241-C-102, 241-C-104, 241-C-107, 241-C-108, and 241-C-112 Tanks Waste Retrieval Work Plan

Tank Operations Contractor (TOC) RECORD OF REVISION		(1) Document Number: RPP-22393		Page <u>1</u>
(2) Title: 241-C-102, 241-C-104, 241-C-107, 241-C-108, and 241-C-112 Tanks Waste Retrieval Work Plan				
Change Control Record

241-C-102, 241-C-104, 241-C-107, 241-C-108 AND 241-C-112 TANKS WASTE RETRIEVAL WORK PLAN

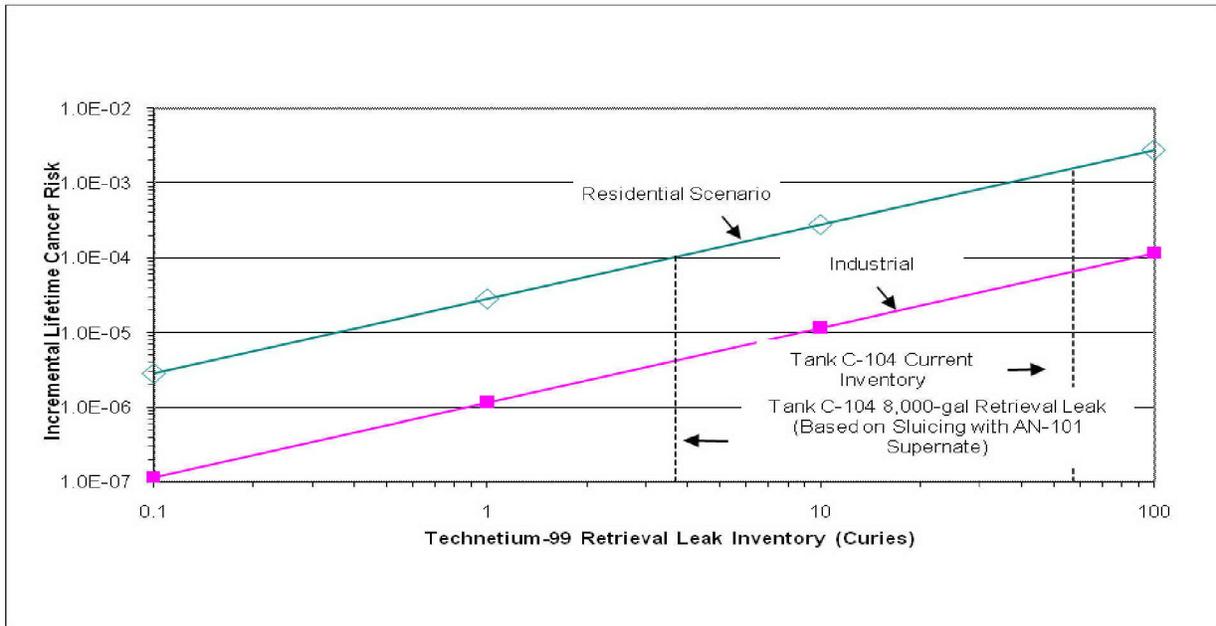
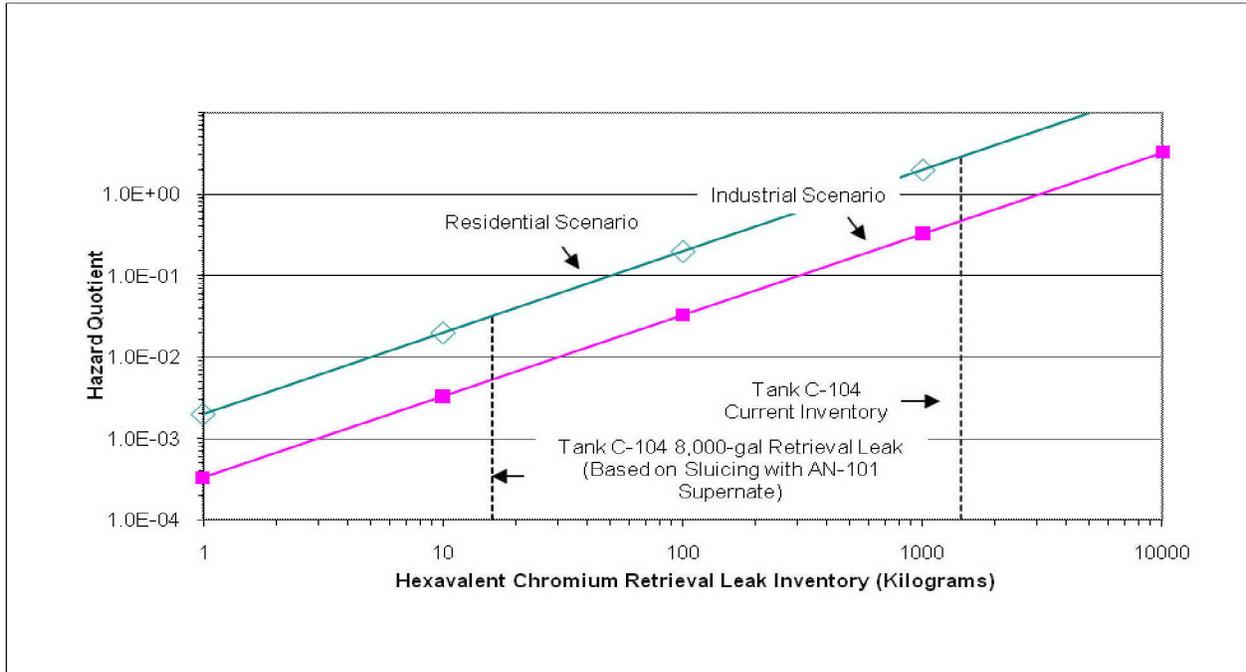
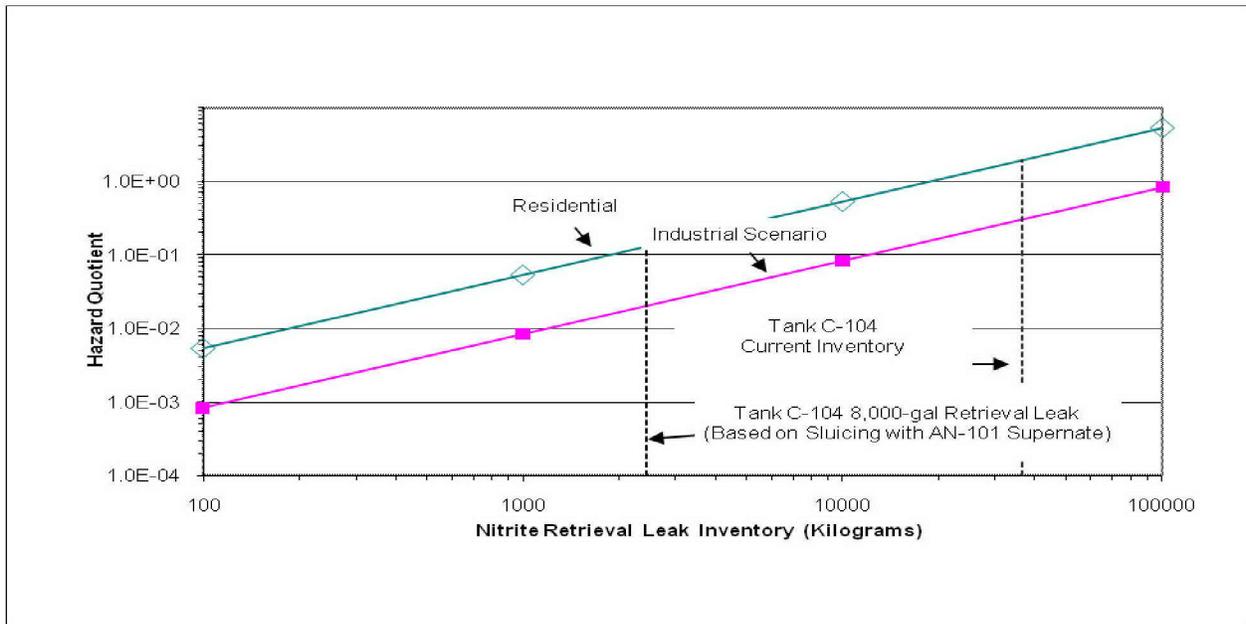
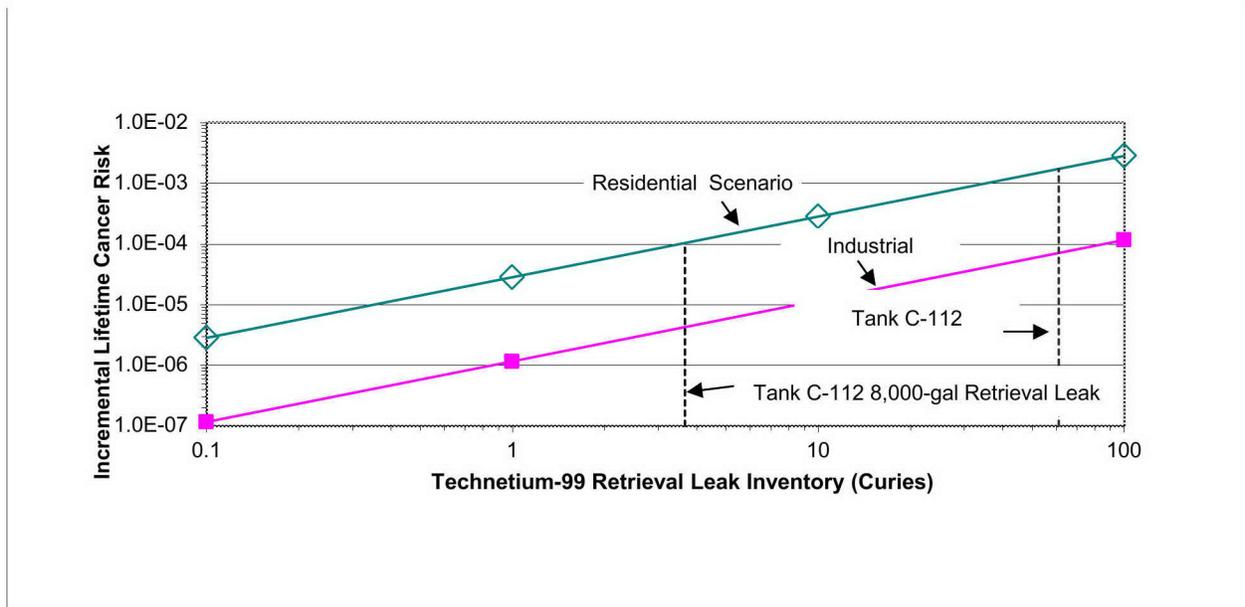
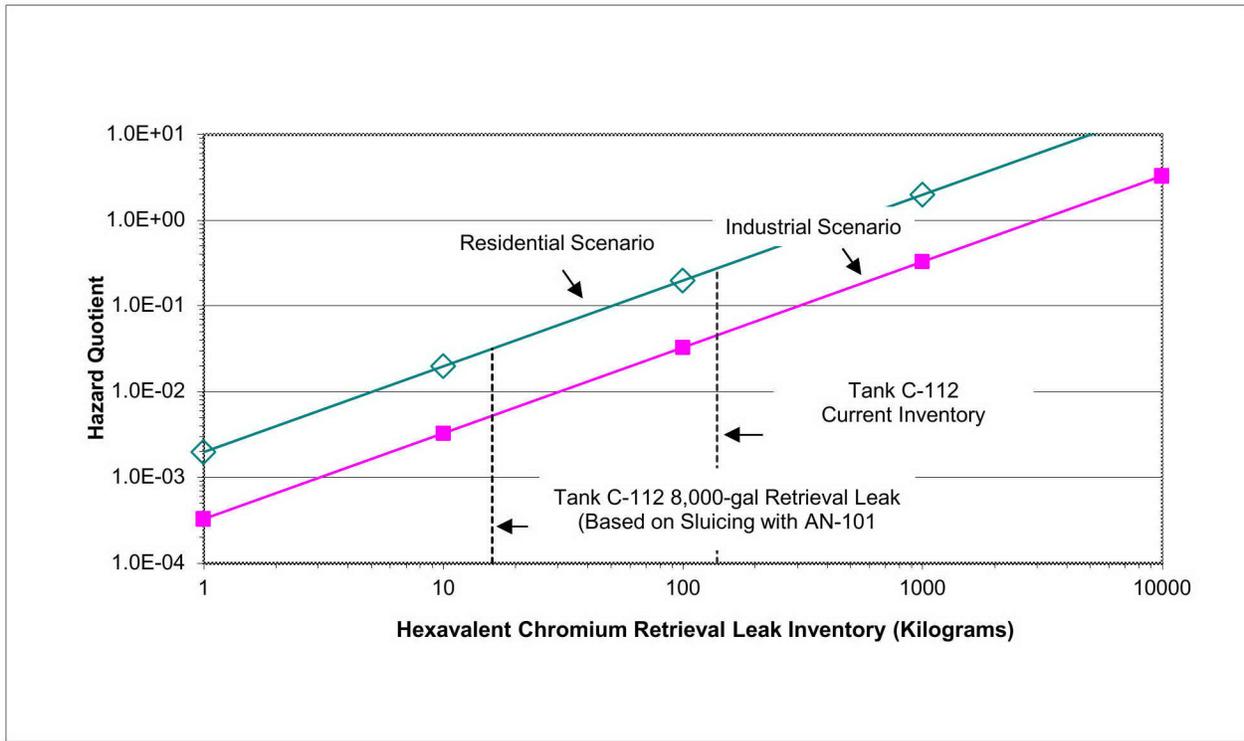
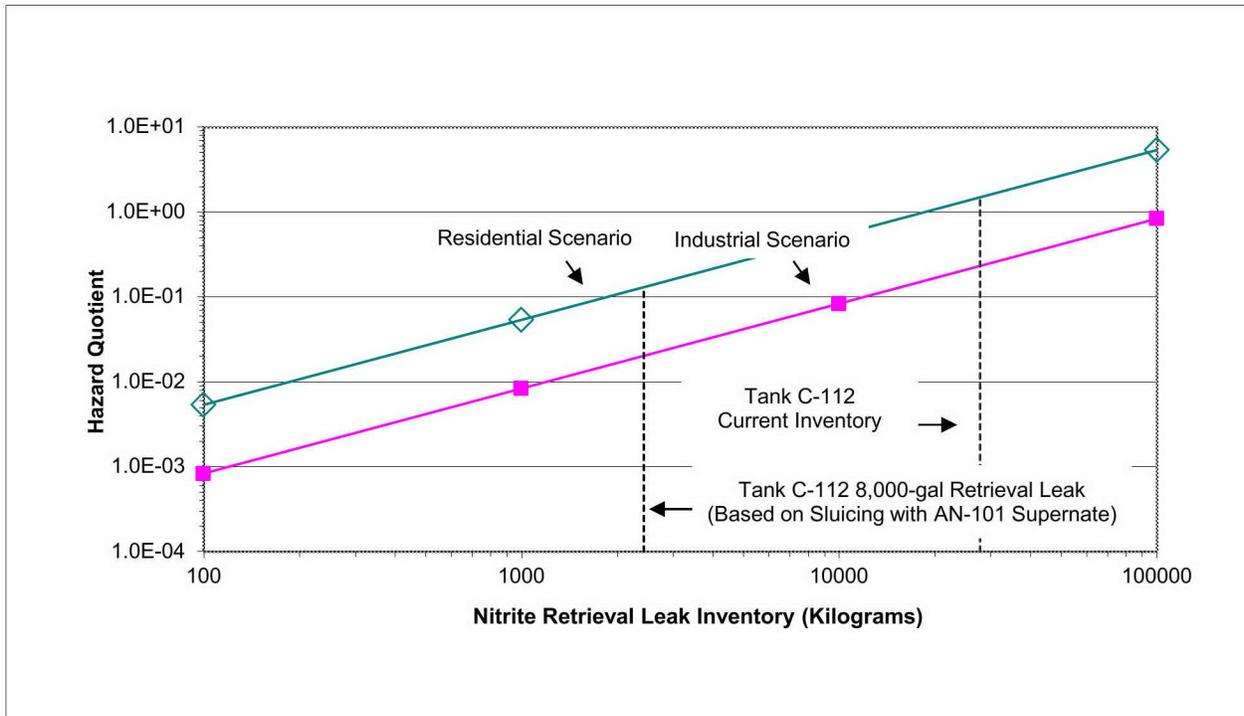
The risk and hazard quotient plot Figures B-1, B-2, B-3, E-1, E-2, and E-3 are replaced as well as necessary numbers and words in the supporting documentation, as can be seen on the attached redline-strikeout copies of the revised appendices. The only change on pg. 3-1 in the main body of the TWRWP is to show AN-101 instead of AN-106 as the source tank for the C-112 sluicing supernate.

Figure D-1. Tank C-108 Technetium-99 Risk Plot.

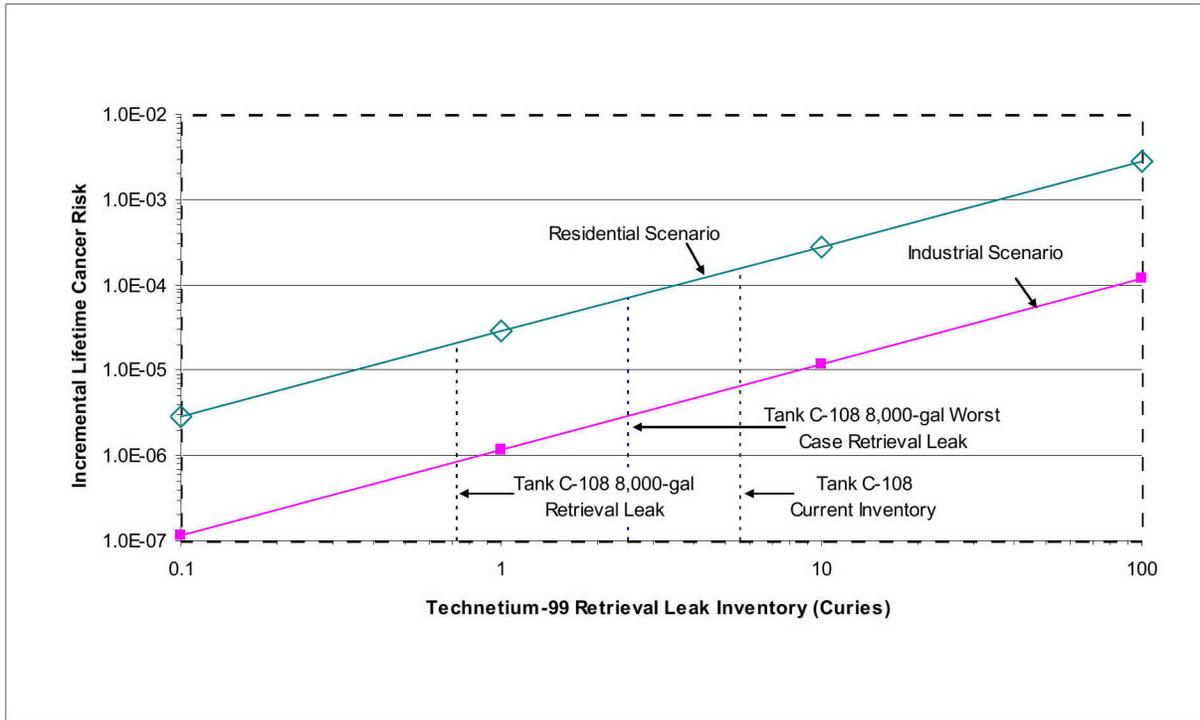
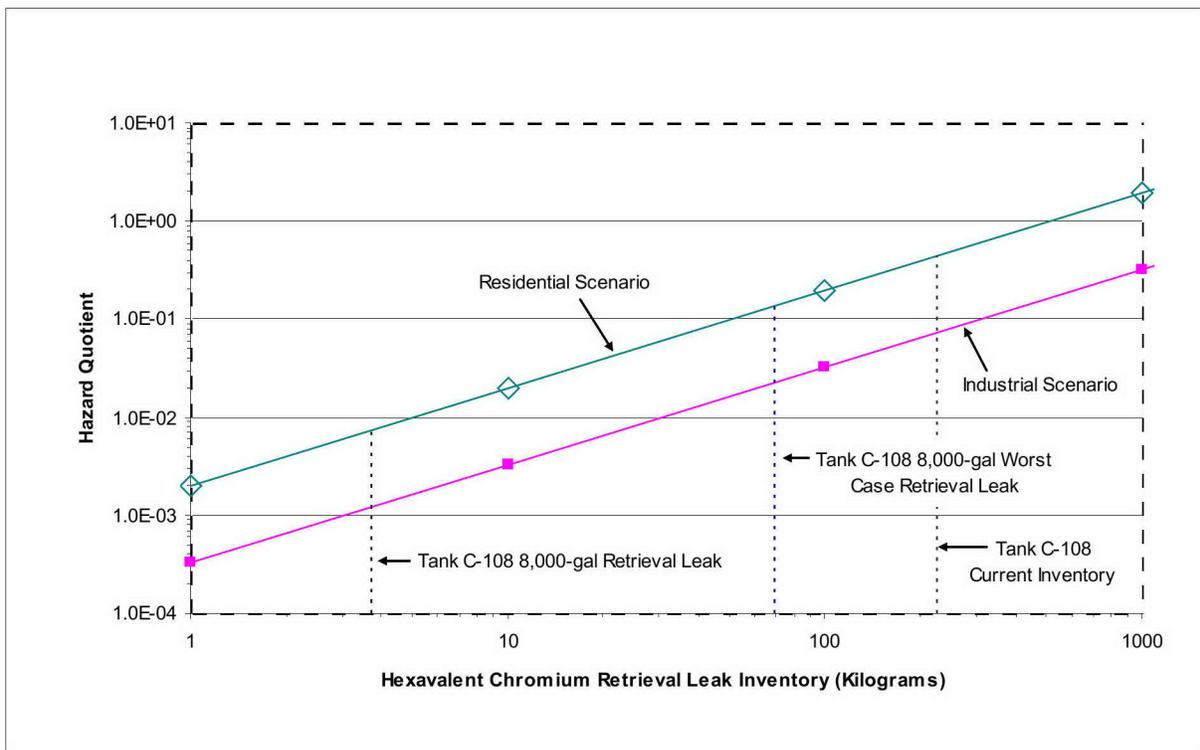
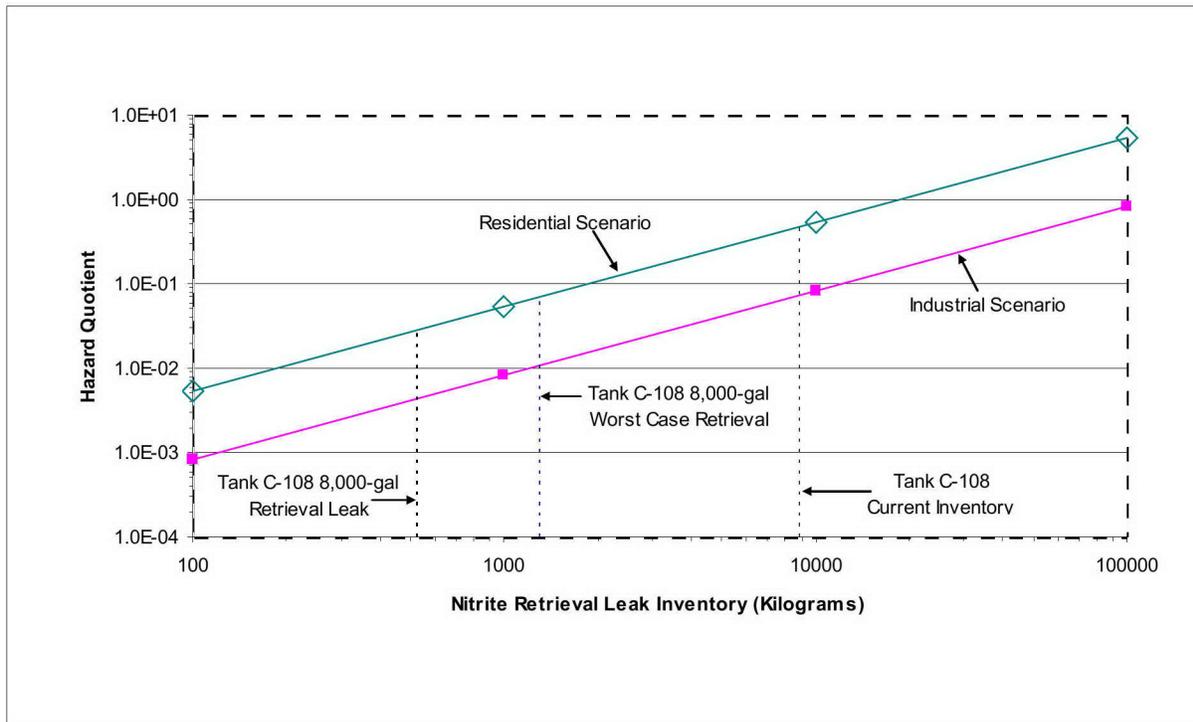
The assumed worst case concentrations used to calculate the estimated risk impact for a leak during retrieval of tank C-108 are given in the middle of pg D-4 of Appendix D of RPP-22393. They are $8.3 \times 10^{-5} \text{ Ci/L}$ for Tc^{99} , 2.3 g/L for Cr, and 43 g/L for NO_2^- . The AN-106 (AY-102) estimated concentrations are all below these numbers. Therefore, the estimated risk associated with the revised waste retrieval plan during C-108 retrieval is still bounded by the worst case impact shown in Figures D-1, D-2 and D-3.

Figure 1 Sketch of C-104 Pits and Transfer Lines

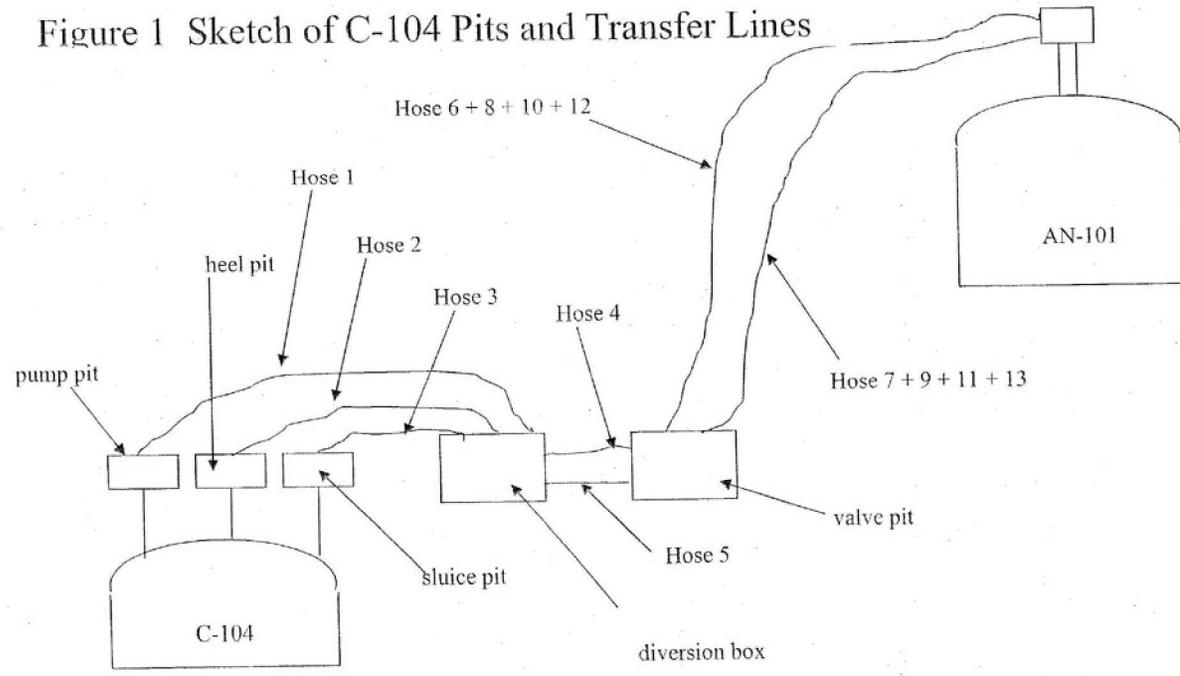
Figure 1 is a simplified sketch of the system for C-104. The design for C-102 has not been initiated yet, but the two tanks are close to each other, have the same pit dimensions, and the distances to an AN Farm receiver tank will be about the same. The conclusions of this calculation are applicable to both the C-104 and C-102 concrete pits.

Figure ES-1. 244-CR Vault Waste pH, Temperature, and Volume Estimates.

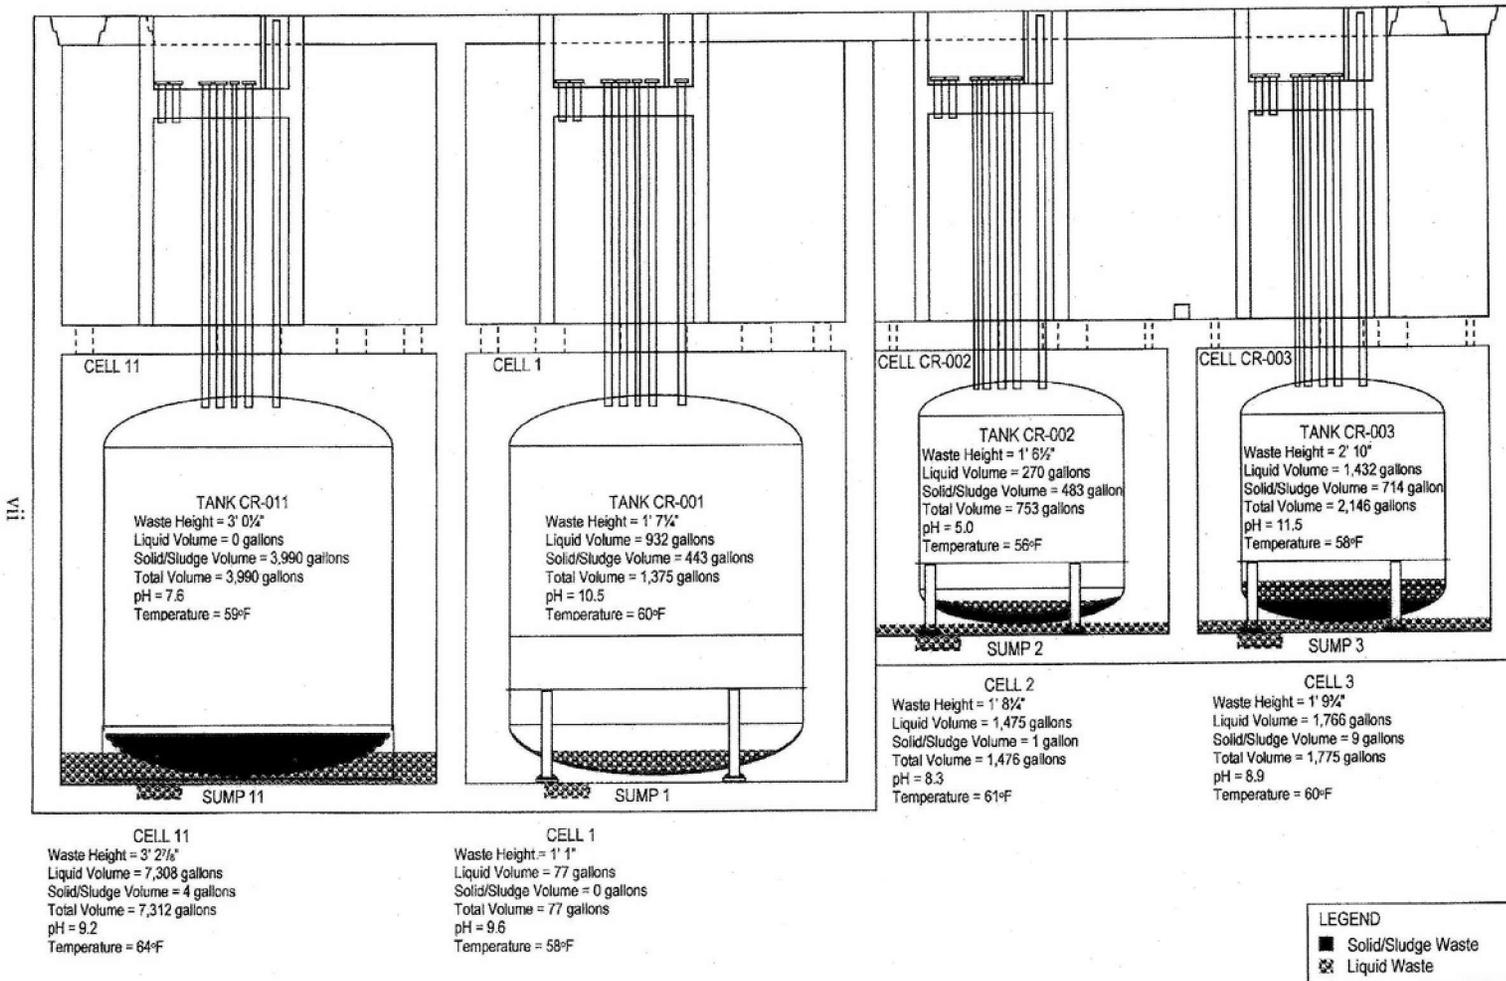
Response: Figure ES-1 from RPP-RPT-24257 Rev 0 is attached.
